Attachment D – Internal Referral Comments

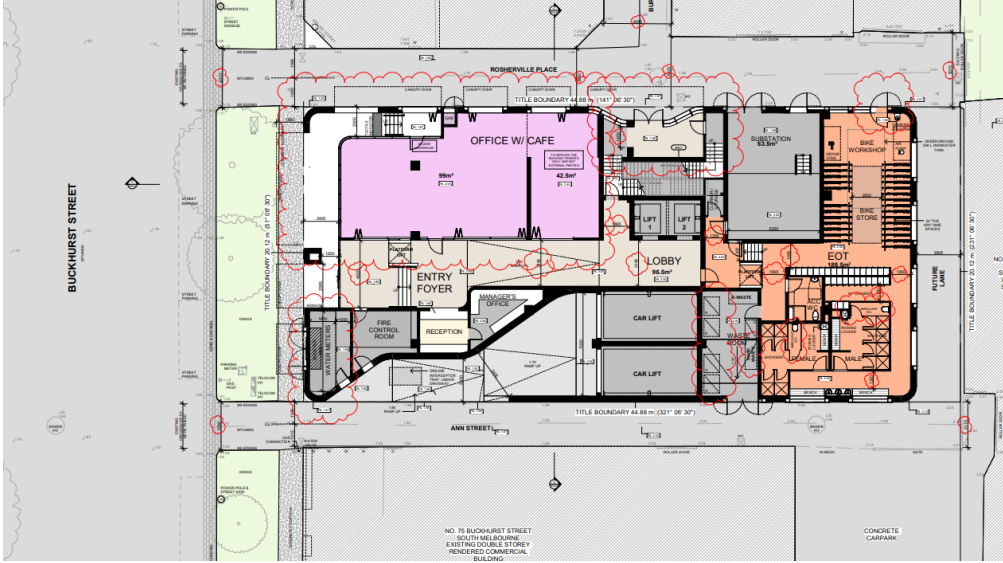
- From my understanding the following areas will require electricity to operate:
 - Water Meters
 - Fire Control Room
 - Reception
 - Manager's office

How will the above areas be protected from being affected by flood water?

- At the Entry Foyer and EOT area it is proposed a platform lift, assuming the lift will be electrically operated, how will it be prevented from it being affected by flood water entering the entrance.
